RE: Addendum #1
Bid 19-900 Poe Springs Road Trail (LAP - FPN 433990-2-58-01)

CONTRACT PLANS
FINANCIAL PROJECT ID 433990-2-58-01 (FEDERAL FUNDS)
ALACHUA COUNTY PROJECT ID 6304

ALACHUA COUNTY
COUNTY ROAD NO. 340 SHARED USE PATH

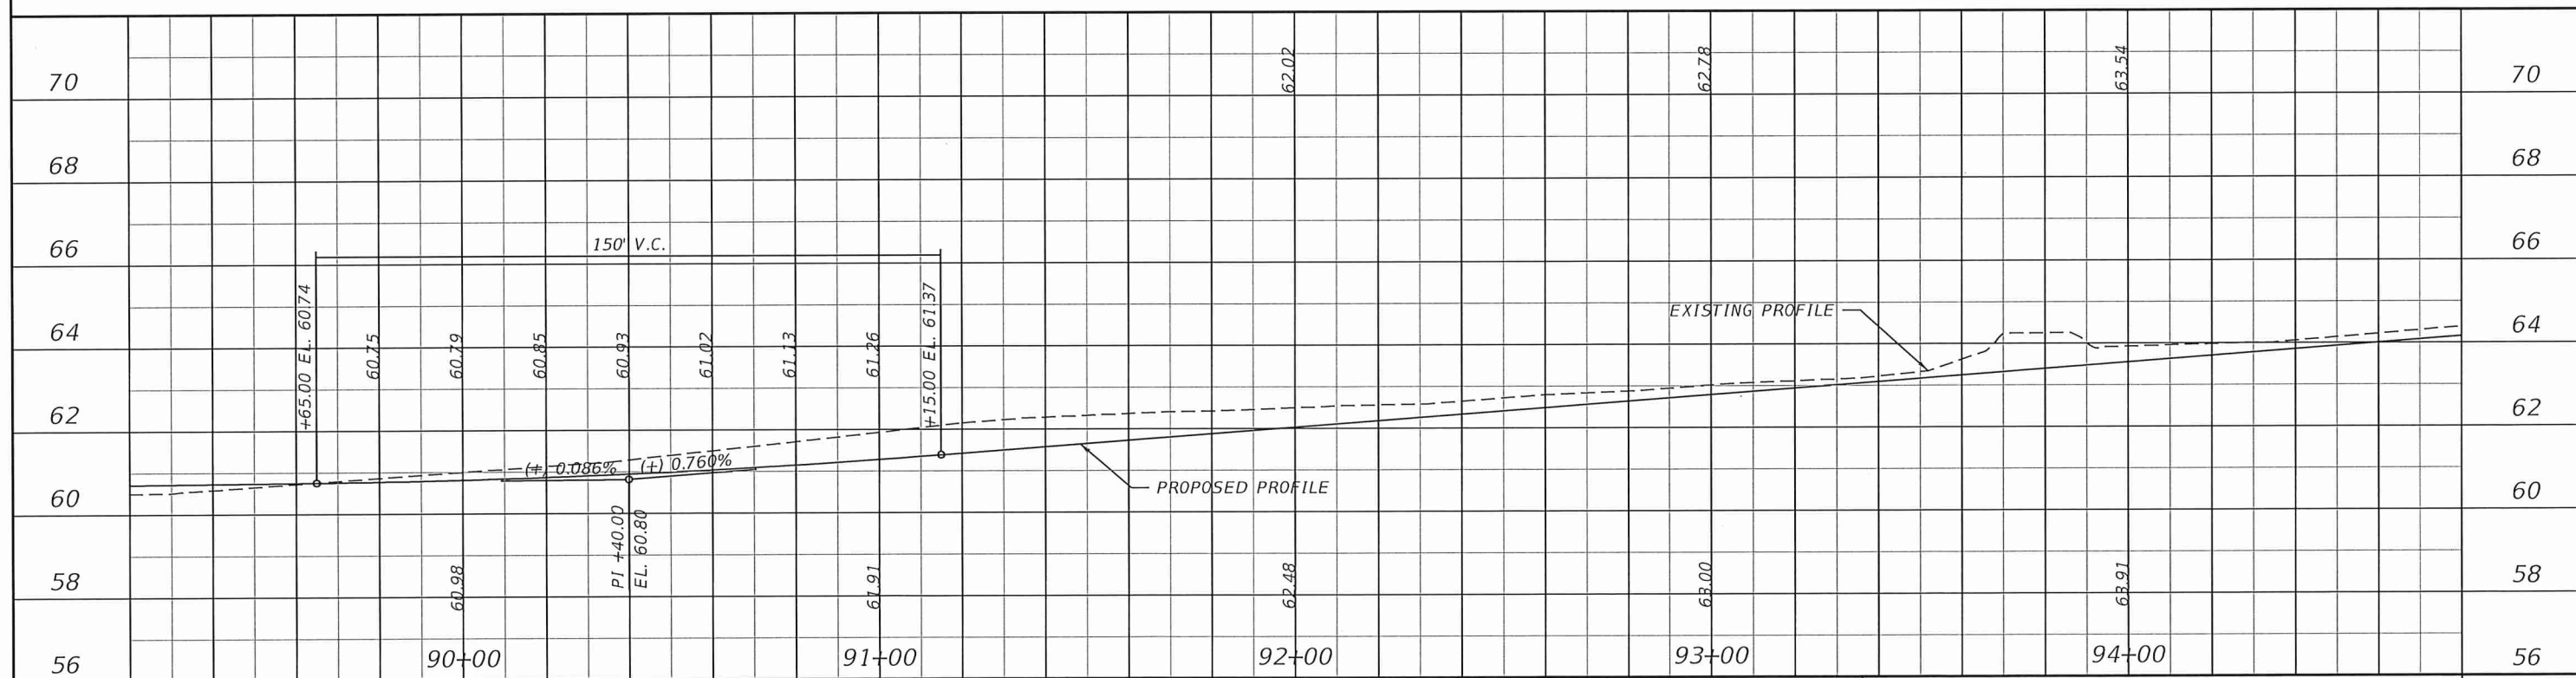
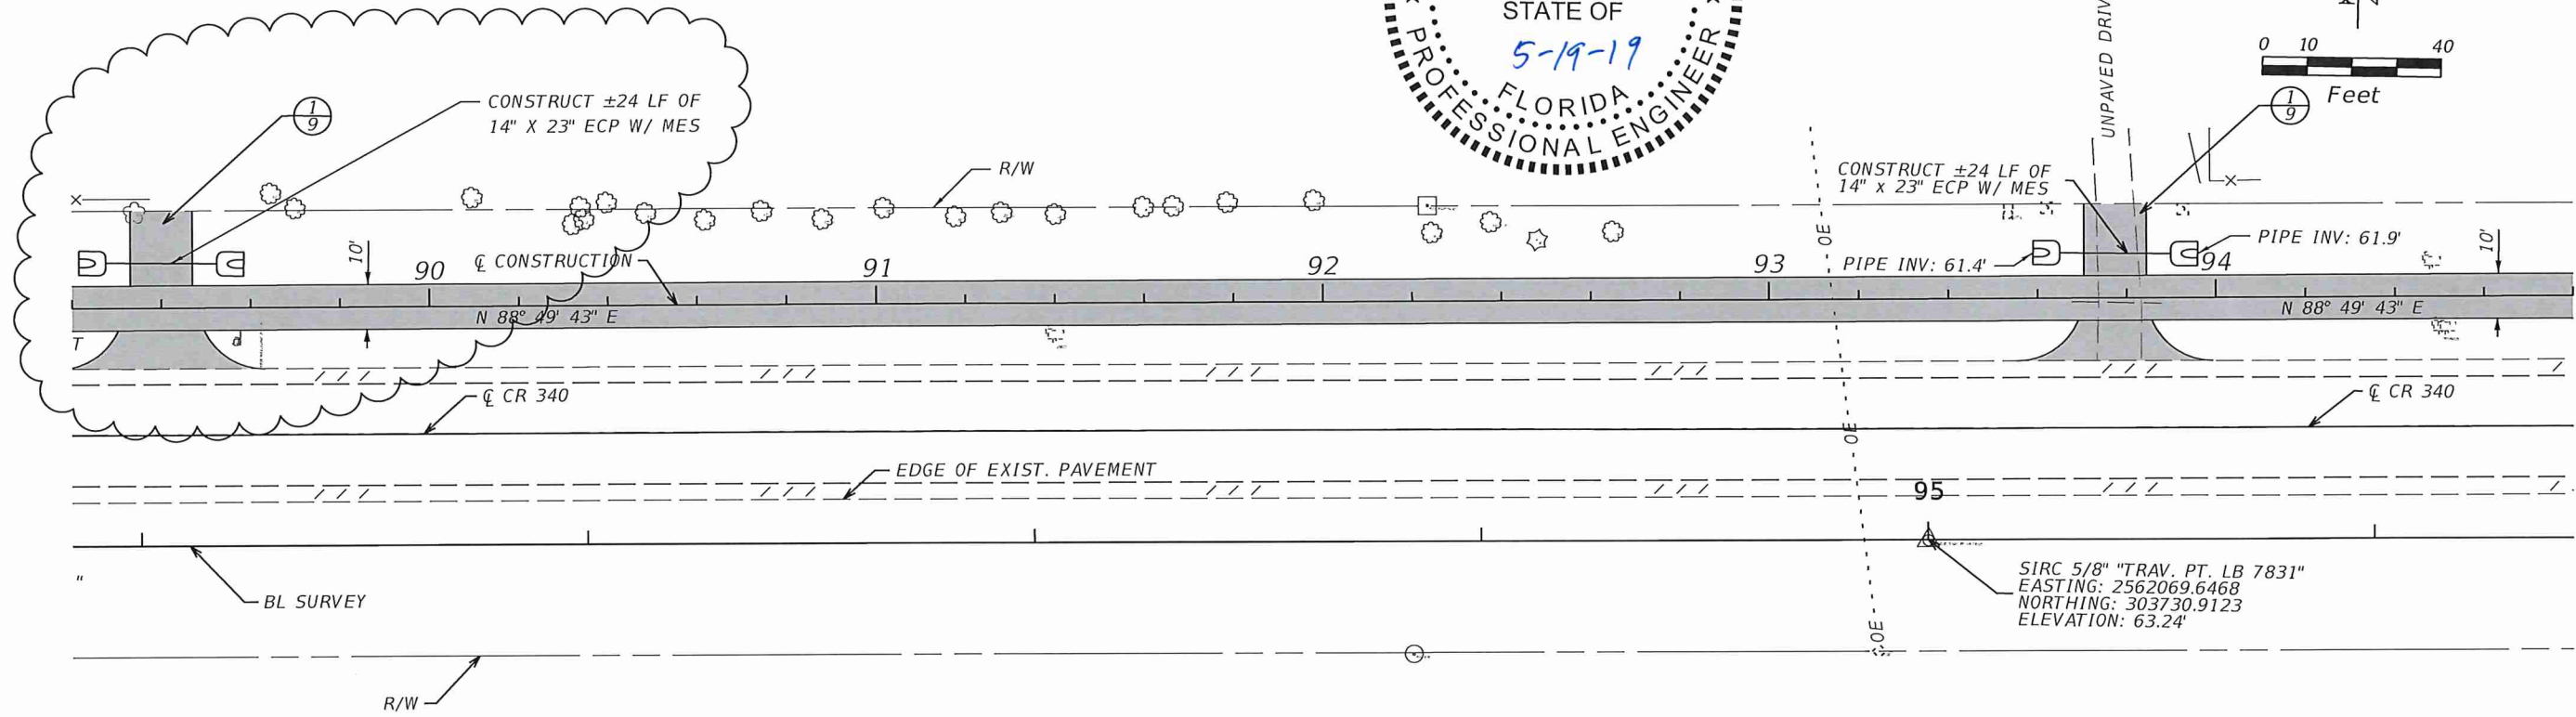
REVISIONS				James H. Pitman Jr., P.E. P.E. LICENSE NUMBER 42035 NORTH FLORIDA PROFESSIONAL SERVICES PO BOX 3823 LAKE CITY FL, 32056 CERTIFICATE OF AUTHORIZATION 29011	ALACHUA COUNTY PUBLIC WORKS			PLAN & PROFILE SHEETS	SHEET NO.
DATE	DESCRIPTION	DATE	DESCRIPTION		ROAD NO.	COUNTY	FINANCIAL PROJECT ID		
5/15/19	△ DRIVEWAY ADDED STA. 89+40.00				CR 340	ALACHUA	433990-2-58-01		28

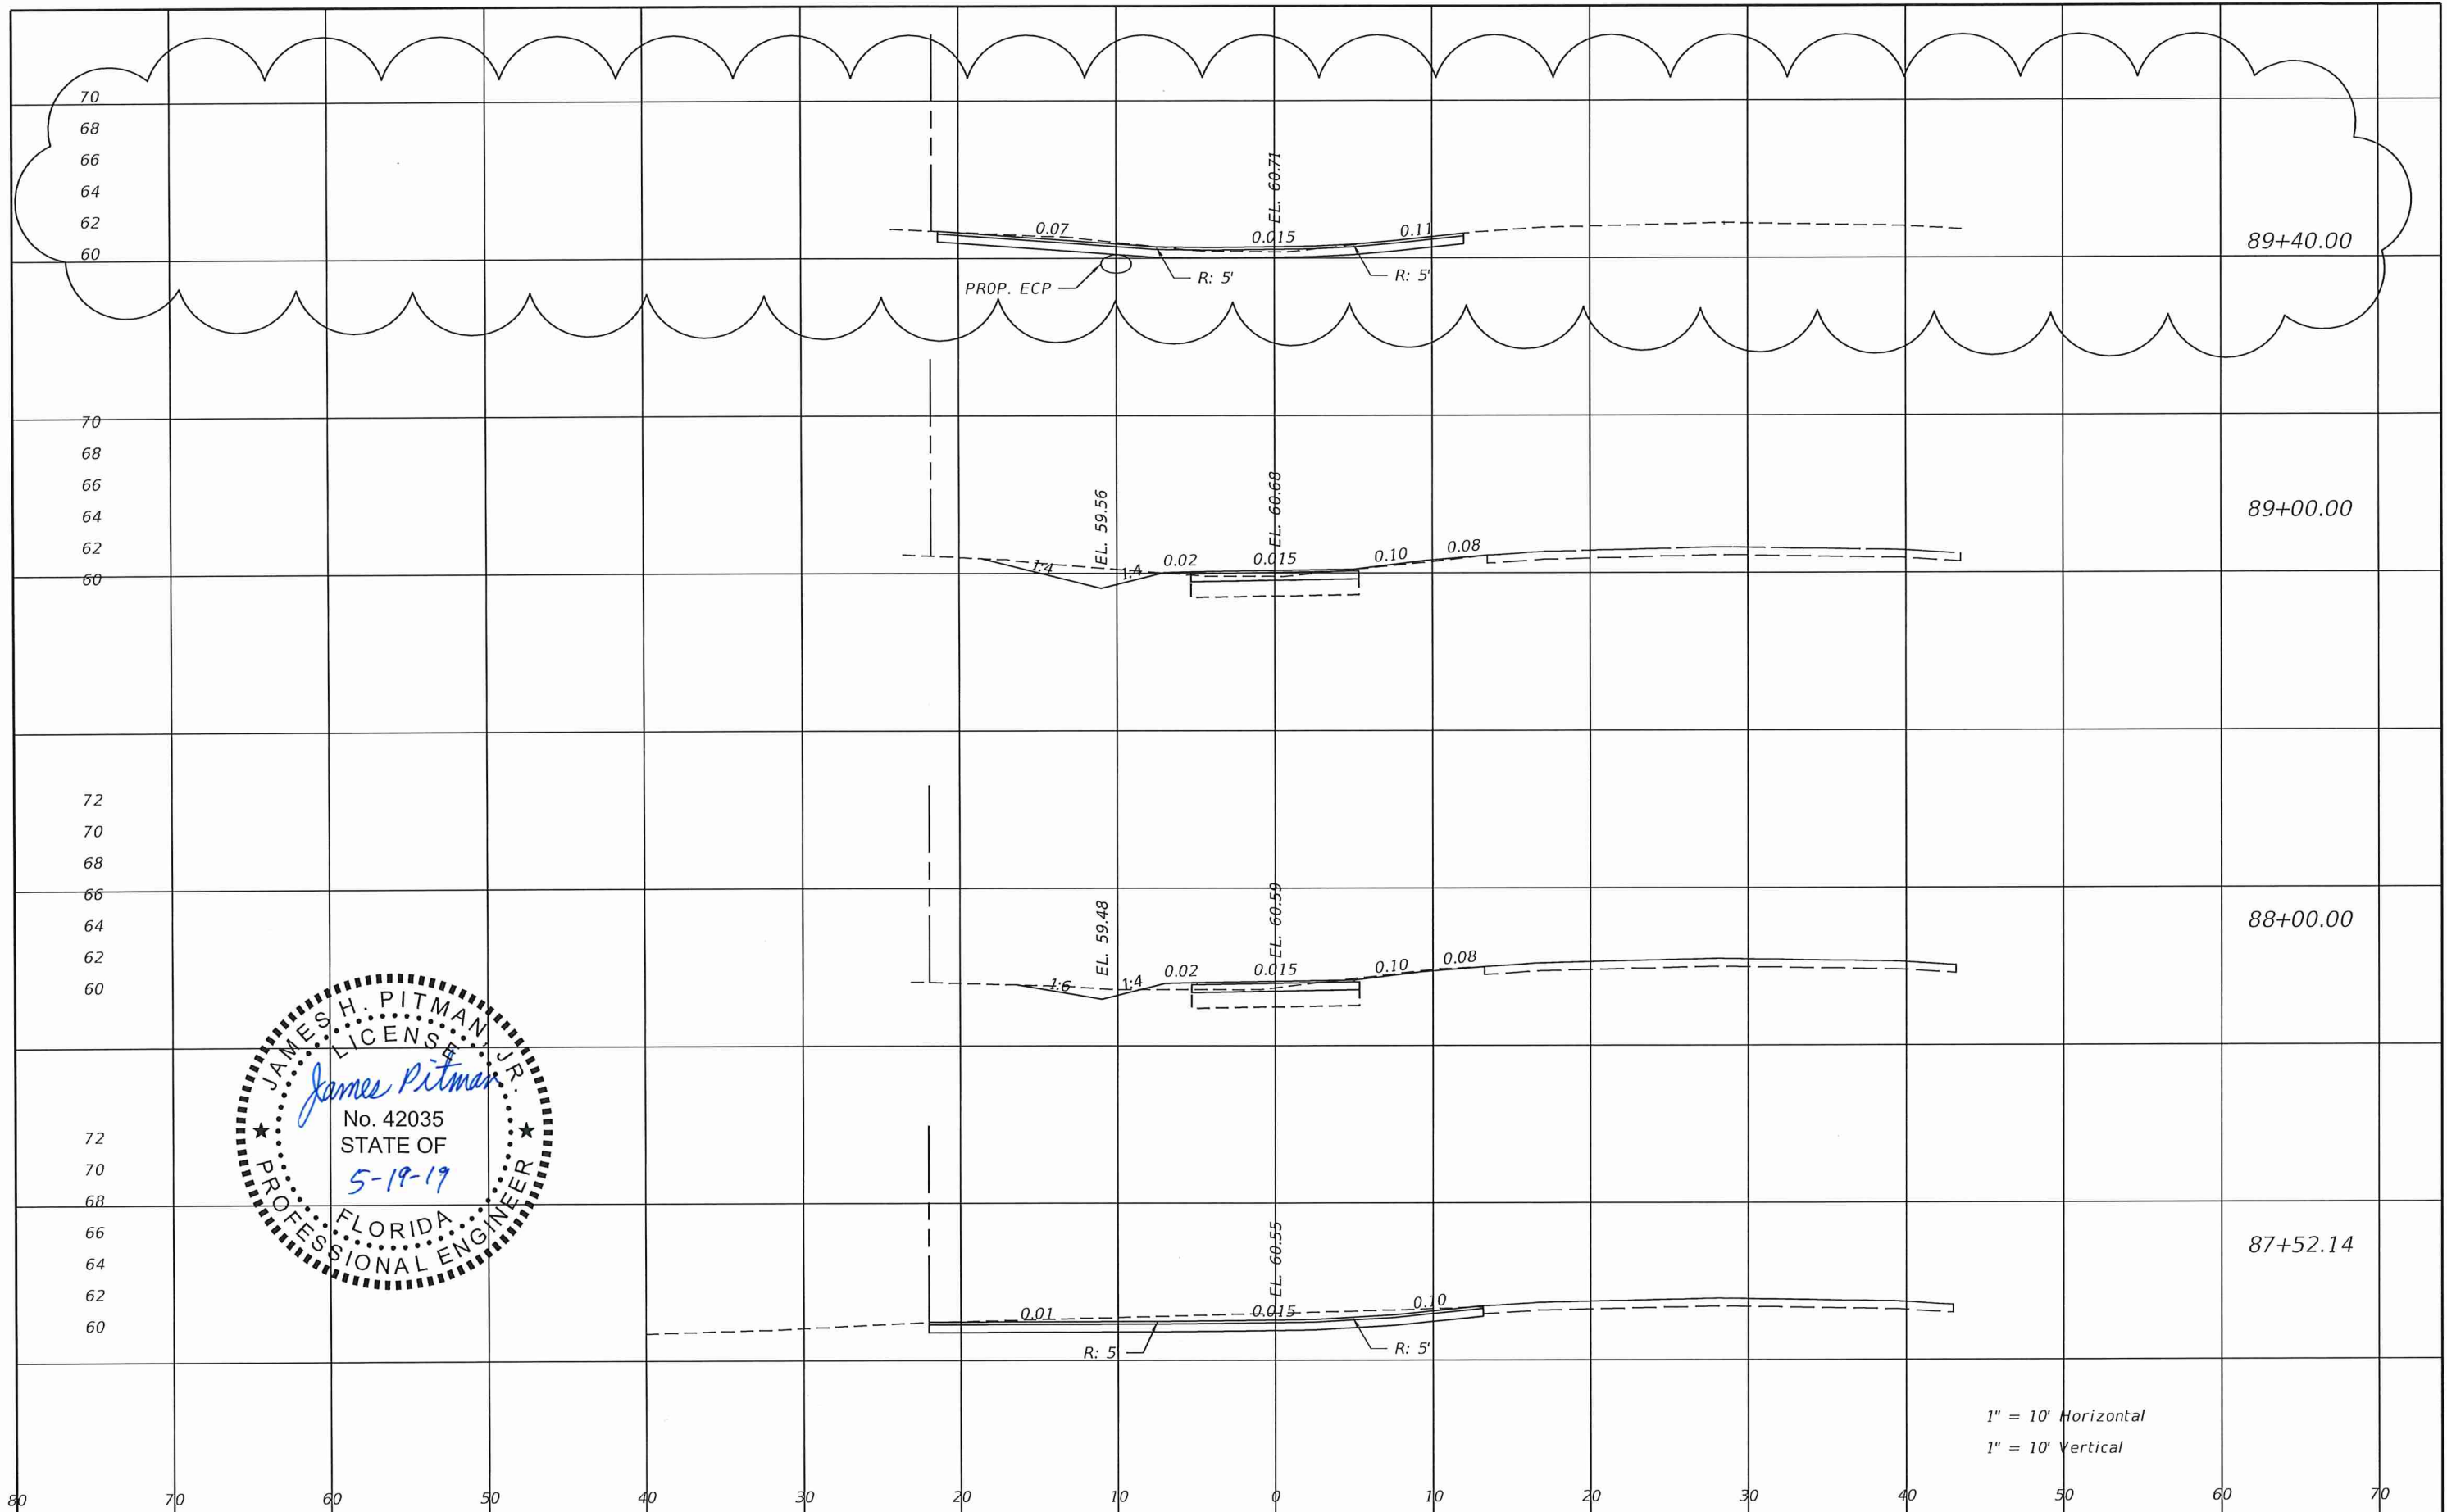
REVISIONS				James H. Pitman, Jr., P.E. P.E. LICENSE NUMBER 42035 NORTH FLORIDA PROFESSIONAL SERVICES PO BOX 3823 LAKE CITY, FL 32056 CERTIFICATE OF AUTHORIZATION 00029011	ALACHUA COUNTY PUBLIC WORKS			CROSS SECTION SHEETS	SHEET NO. 79
DATE	DESCRIPTION	DATE	DESCRIPTION		ROAD NO.	COUNTY	FINANCIAL PROJECT ID		
5/15/19	△ DRIVEWAY ADDED				CR 340	ALACHUA	433990-2-58-01
